9 November 2017

610.14692-L01-v0.1 RTS Water Quality 20171109.docx

Mortdale Resource Recovery Facility
Response to DPE Comments Regarding Water Quality

Extracted from Humes (2016)

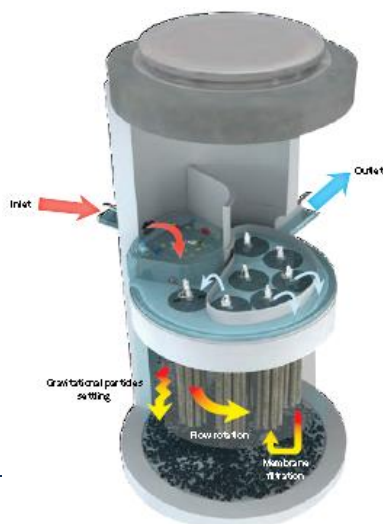
In the absence of site specific water quality targets, pollutant reduction targets have been adopted from the Landcom Water Sensitive Urban Design – Book 1. This requires a GPT which has nutrient removal capability.

The previous stormwater strategy proposed the use of a Rocla First Defence GPT. The *First Defence* treatment device would improve water quality from the existing situation. The First Defence provides treatment in terms of sediment, suspended solids, free oil and sediment bound heavy metal removal, but is not effective in removal of nutrients (Phosphorous and Nitrogen).

To achieve the pollutant reduction targets, particularly nutrients, the proposed GPT has been changed to a Humes Jellyfish Gross GPT.

- Use of a Humes Jellyfish GPT (Not Rocla's First Defence unit as originally proposed);

The MUSIC modelling carried out with this study includes a Humes Jellyfish GPT with membrane cartridges that provide improved fine particle and nutrient removal rates. The pollutant removal rates published by Humes and achieved from independent testing are as follows: TSS 85%, TP 59%, TN 51%, Cu 90%, and Zn 70%. Other types or arrangements of GPT with similar pollutant removal rates should also be satisfactory.
